AC Charging Hardware and Cable Temperature

Models	Model Year	Model Type	VIN Range	Vehicle-Specific Equipment
Taycan	As of 2020 up to 2023	All	All	73E, 73C

Revision History

Figure 1

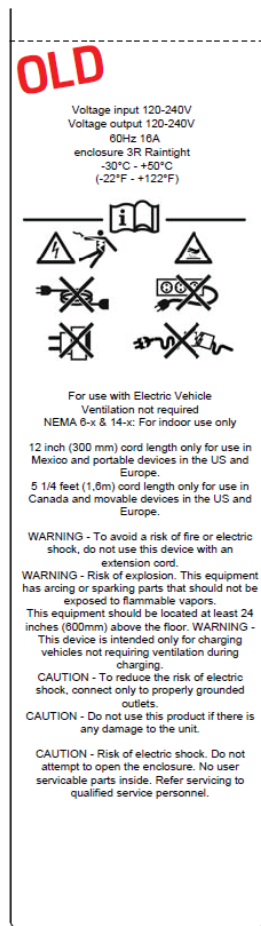
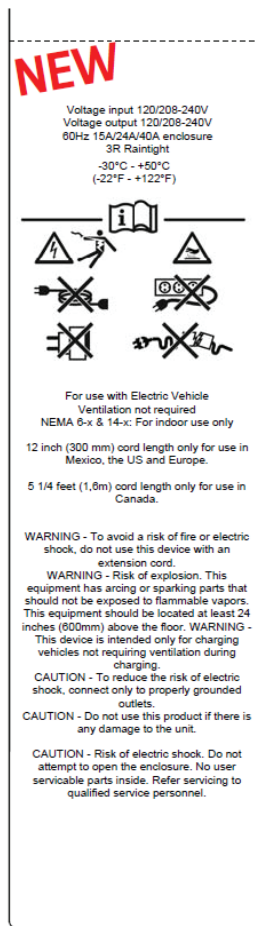
Errors may exist in the label affixed to supply cables provided with vehicles and cables produced through Calendar Year 2020.

Only one label variant exists and is affixed to all supply cables in USA and Canada (NEMA5-15, 6-/14-30, and 6-/14-50). Figure 1 shows the existing label with errors. Figure 2 shows the updated label.

Supply cables fitted with labels with errors are addressed with Workshop Campaigns WMP4 or WNM6.
